Aircraft Industries

MANDATORY BULLETIN

MB No.: L410UVP-E/137a Revision 1

Subject: Extension of registered parameters of the FA 2200 Flight Data Recorder.

Fig. 1

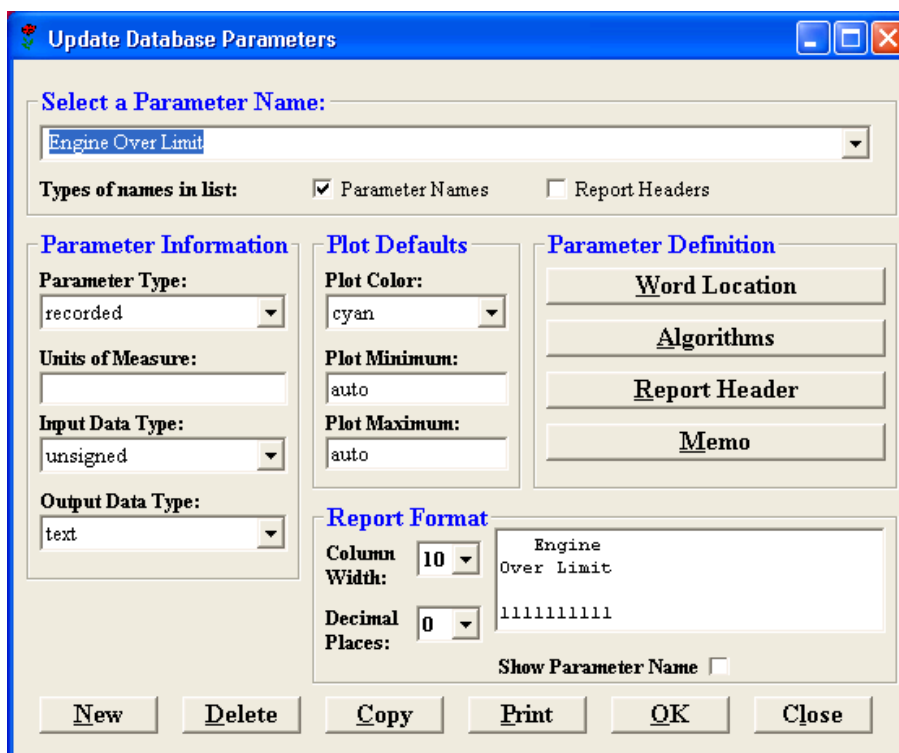
- Perform updating of the *Water Injection* parameter as follows:
 1. In the window „Select a Parameter Name“ select the item *Water Injection*.
 2. Overwrite *Water Injection* to *Engine Over Limit* according to the Fig. 1. Click “OK” to confirm.

Fig. 2

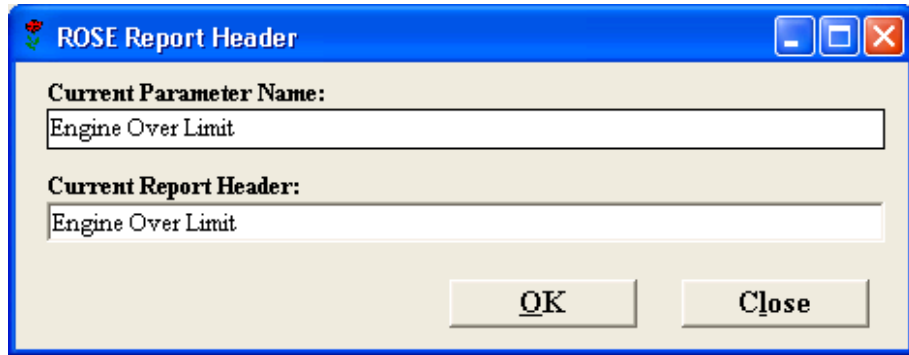
3. Click “Report Header”. Overwrite item “Current Report Header” according to the Fig. 2. Click “OK” to confirm.

Fig. 3

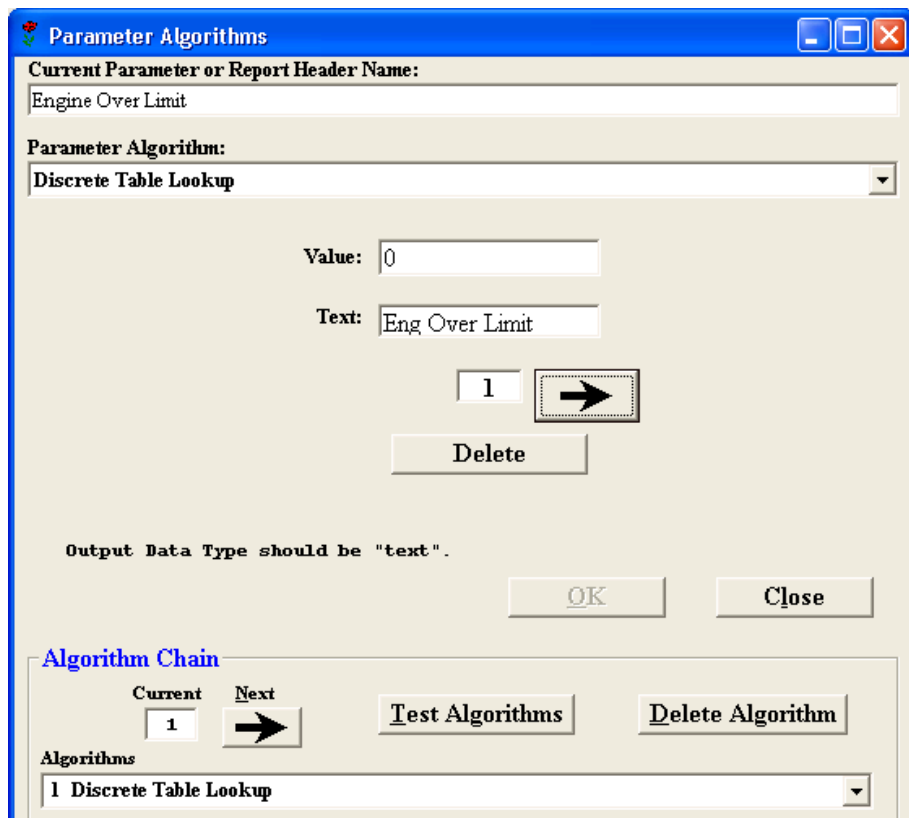
4. Click "Algorithms". On page "1", item "Value" 0, overwrite item "Text" to *Eng Over Limit* according to the Fig. 3. Click "OK" to confirm.

Fig. 4

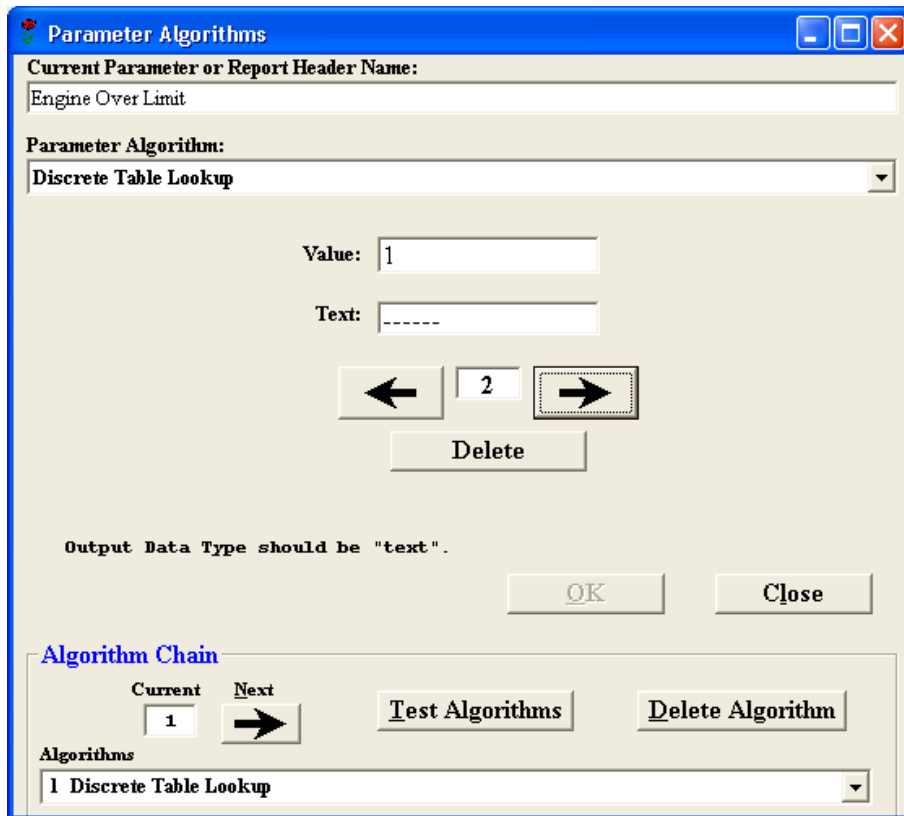
5. On page "1" select „→“. On page „2“, item „Value“ 1, check item "Text". It have to respond Fig. 4. Return back to the window "Update Database Parameters".

Fig. 5

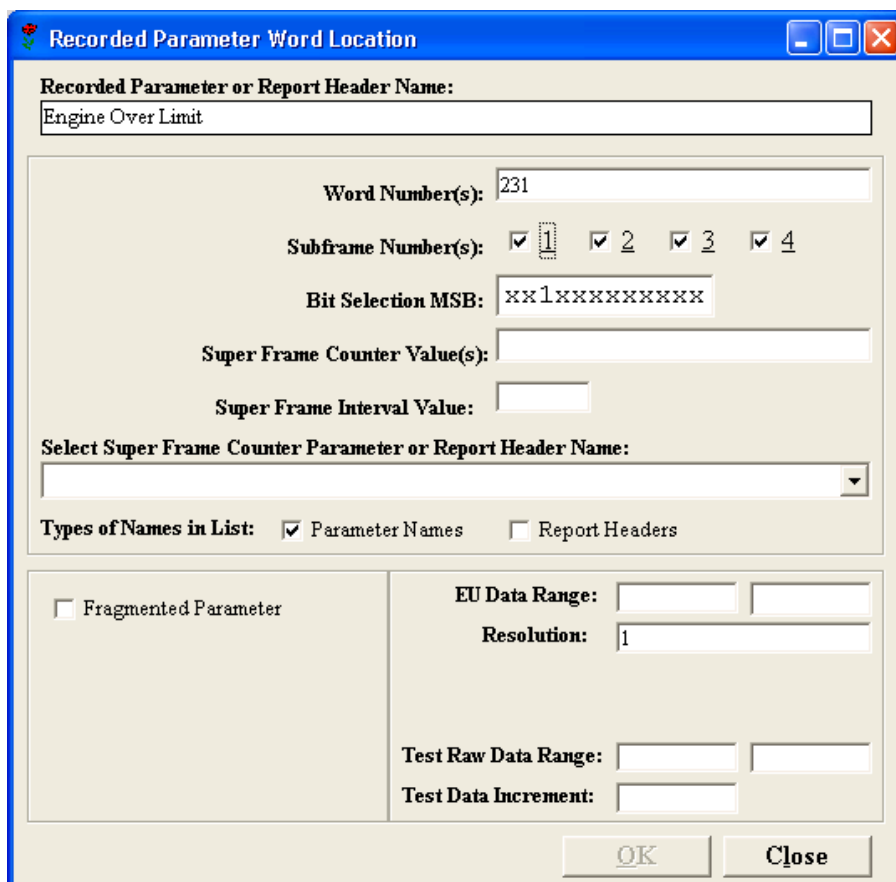
- Click "Word Location". Check all window items according to the Fig. 5, correct any discrepancies. Return back to the window "Update Database Parameters".

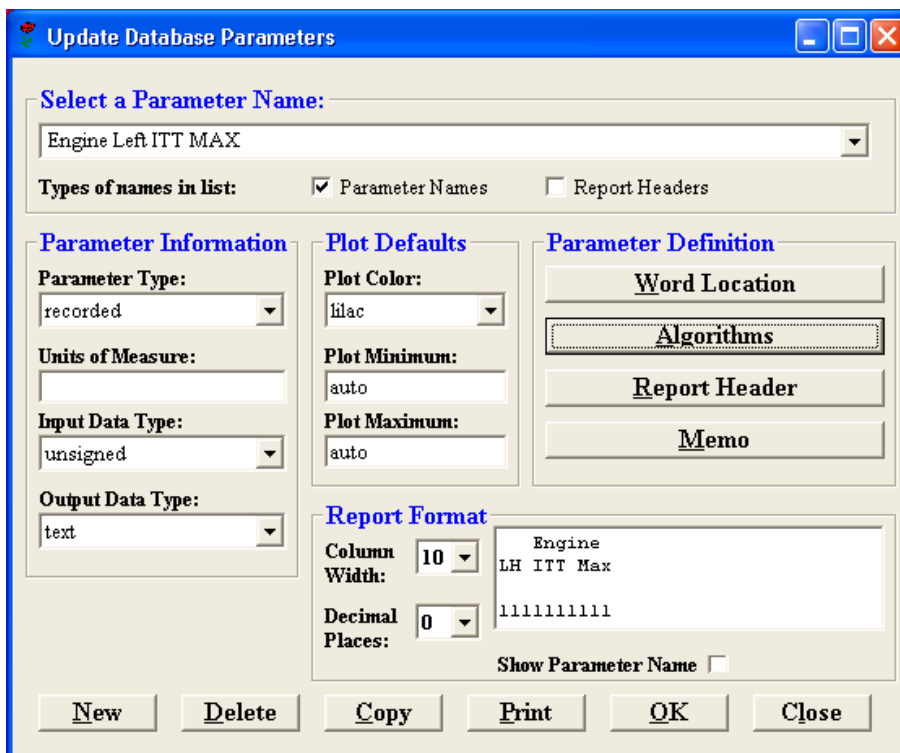
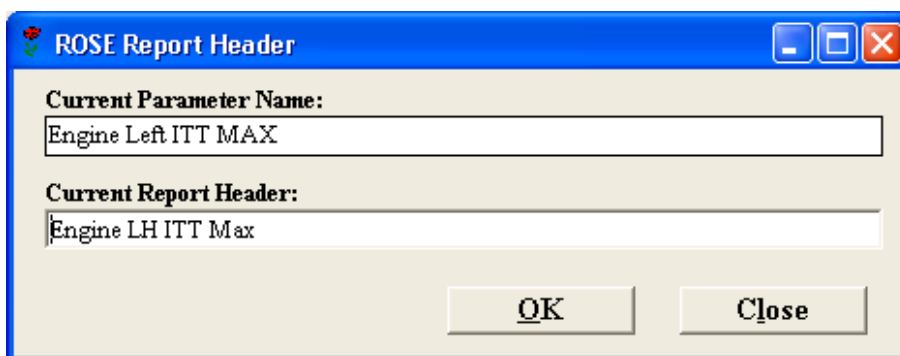
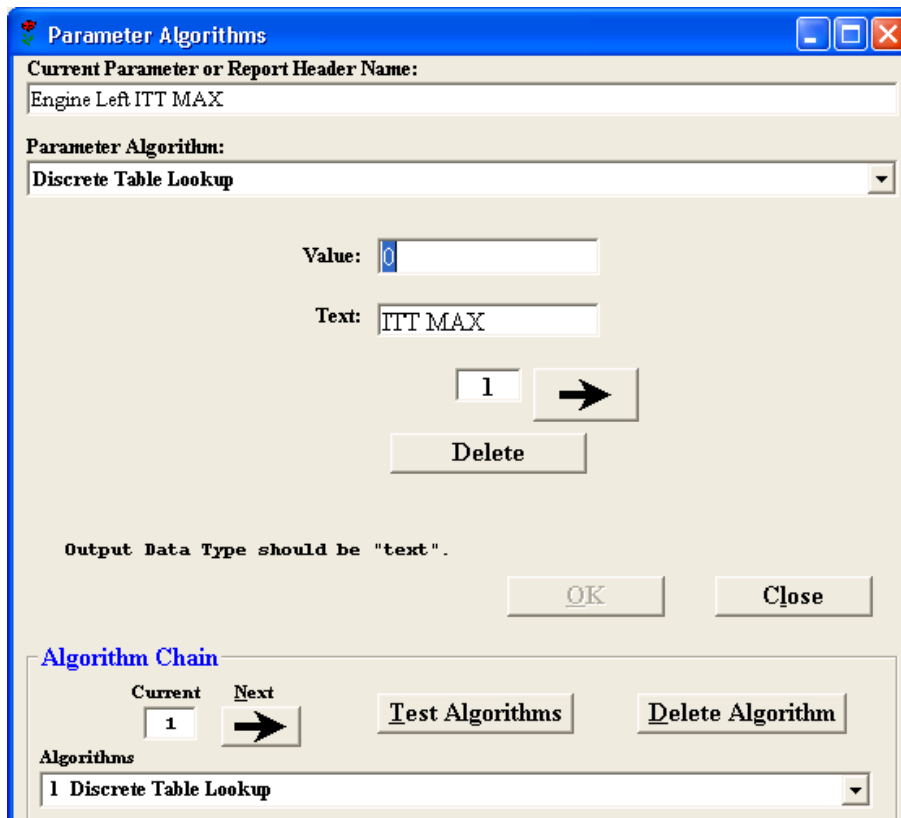
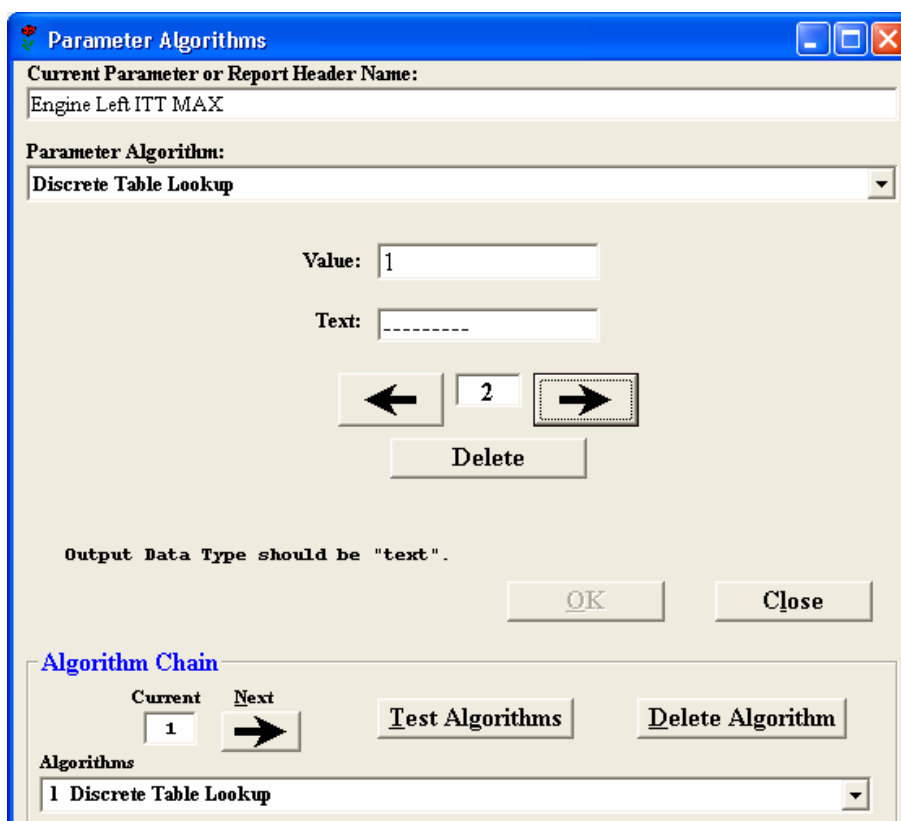
7. Check window "Update Database Parameters" according to the Fig. 1. Click "OK" to confirm.
- Perform updating of the *Engine Left IELU Intervention* parameter as follows:
 1. In the window „Select a Parameter Name“ select the item *Engine Left IELU Intervention*.
 2. Overwrite *Engine Left IELU Intervention* to *Engine Left ITT MAX*. Perform the update according to the *Water Injection* parameter modification, points 2 to 7. Particular items update according to the Fig. 7 to 11.

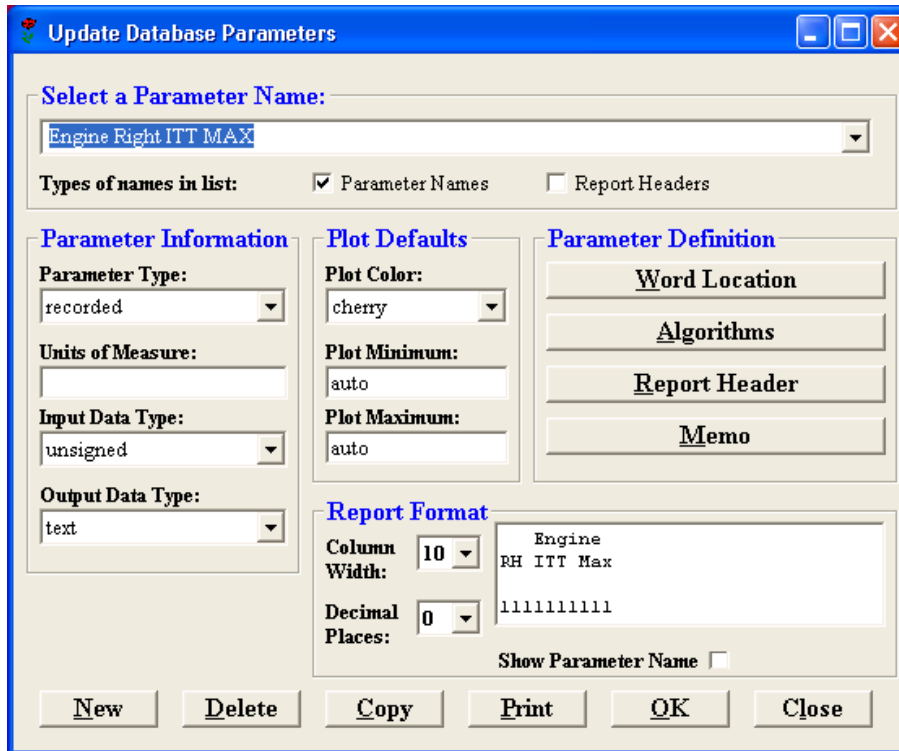
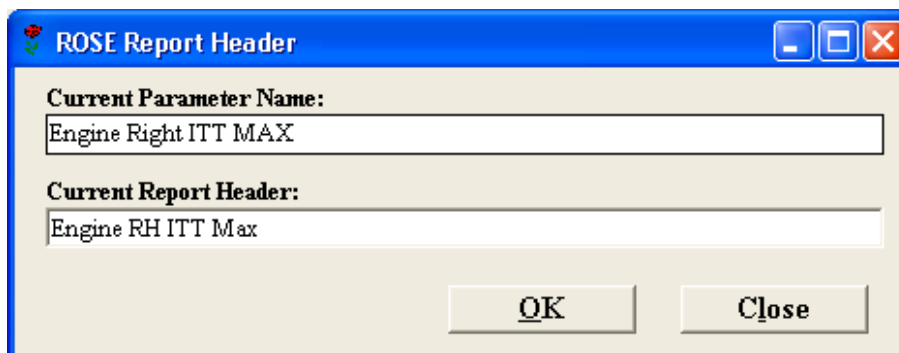
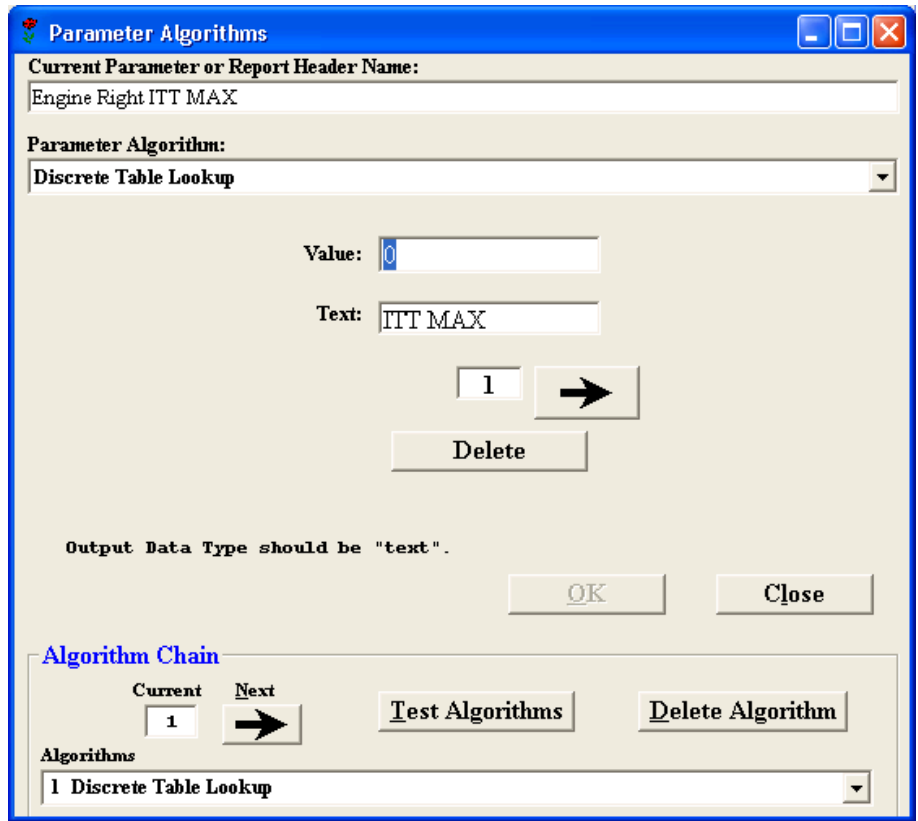
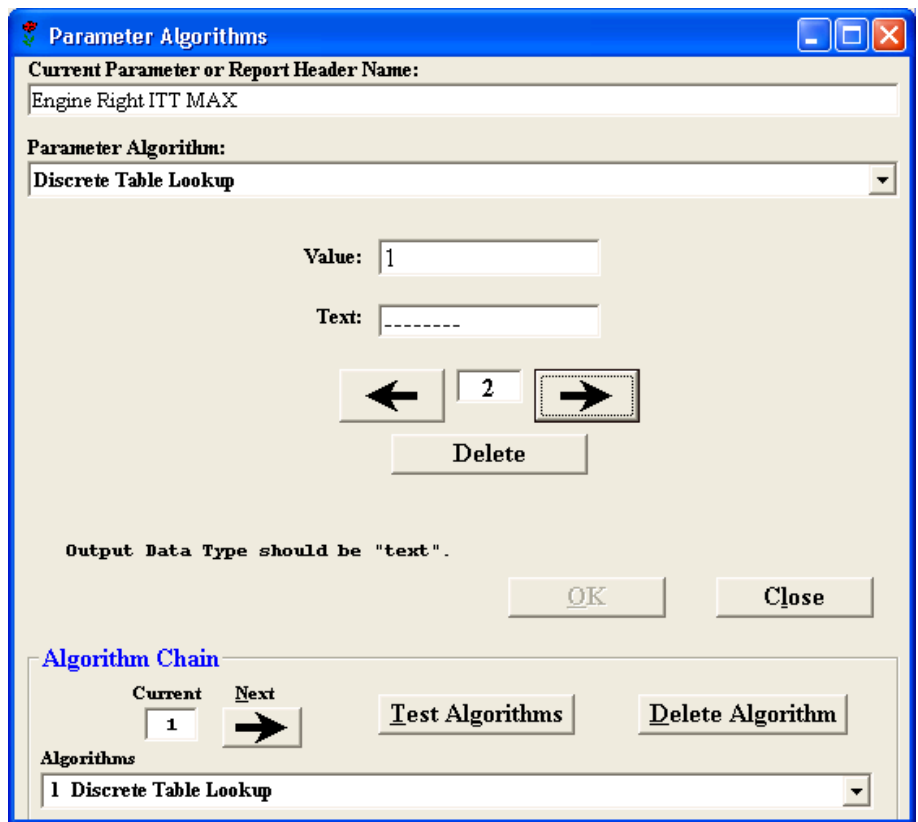
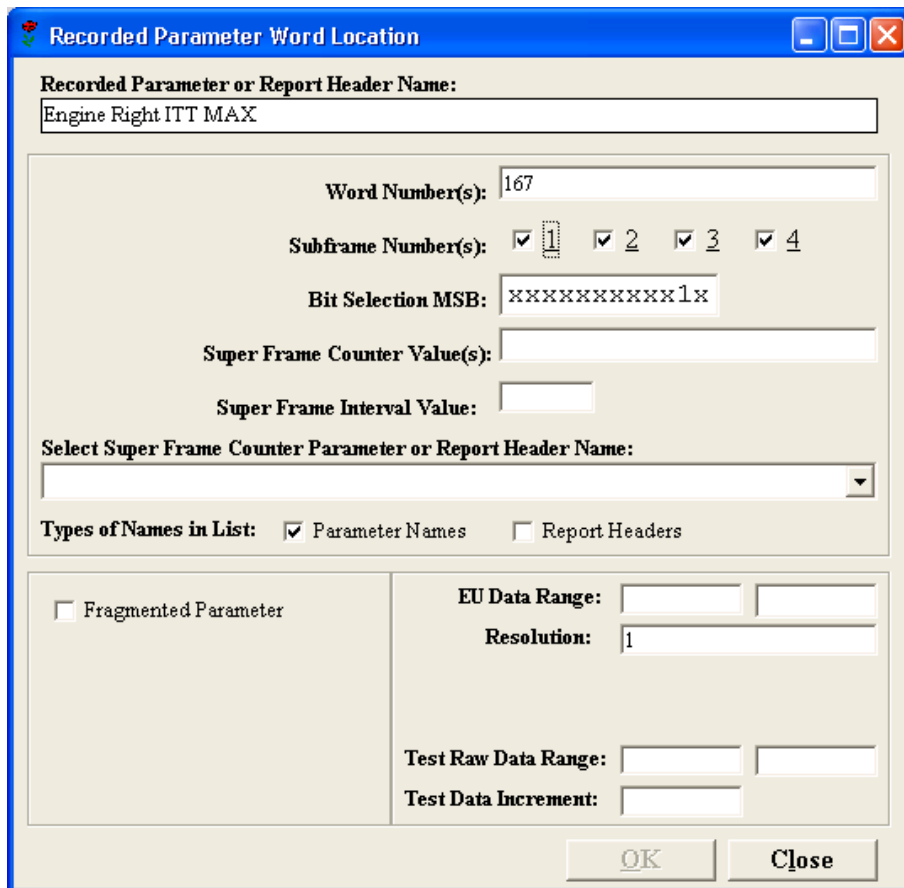
- Perform updating of the *Engine Right IELU Intervention* parameter as follows:
 1. In the window „Select a Parameter Name“ select the item *Engine Right IELU Intervention*.
 2. Overwrite *Engine Right IELU Intervention* to *Engine Right ITT MAX*. Perform the update according to the *Water Injection* parameter modification, points 2 to 7. Particular items update according to the Fig. 12 to 16.
